South Texas Project
Unit 2
Docket No. STN 50-499
Response to Request for Additional Information Regarding
2RE10 Steam Generator Inspection

Reference: Letter, J. W. Crenshaw to NRC Document Control Desk, "Special Report – 2RE10 Refueling Outage Inservice Inspection Results for Steam Generator Tubing," dated June 16, 2004 (NOC-AE-04001741)

Response to Request for Additional Information

Figure 1

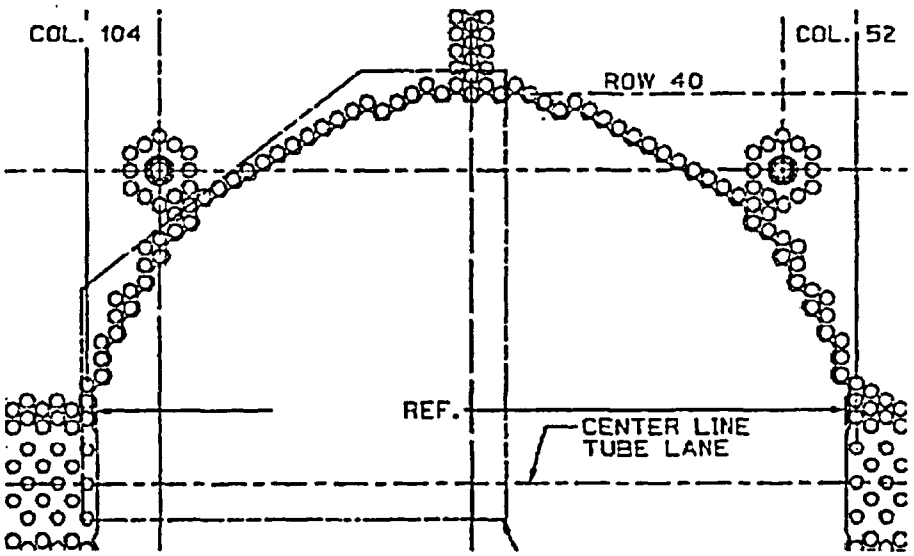
b. On page 3 of the report, you indicated that you performed rotating probe inspections at locations below the baffle plate cut out region and on the periphery of the bundle from one inch above to four inches below the secondary face. Please clarify what constitutes the cut out region of the baffle plate and discuss the results of any similar inspections performed during your 2004 outage.

The central cut out area is a circular symmetric cutout of ~ 43" diameter on the hot and cold leg central bundle position. Refer to Figure 1. No specific inspection of these areas were required or performed during 2RE10. The PSI of the baffle cut out region was performed only to obtain baseline rotating coil data for these areas should STP bobbin coil examinations encounter possible loose parts later in service.
